Product Change Notification

1. ECR #: 193685
Notification #: 522

- UMPT - UMPT ASSEMBLY

- UMPT-XX-XX.X-X-VT-XX-X-XX-X-X

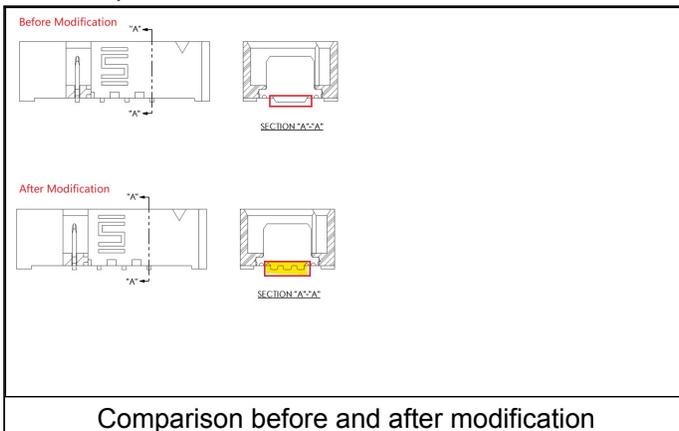
Update model from flat SM tail to grooved SM tails.

Modified contact tails by adding contour to increase solderable surface area and improve solder joint integrity. Revised contact tails passed standard qualification and interconnect processing tests.

- Function - Modified contact tails by adding contour to increase solderable surface area and improve solder joint integrity.
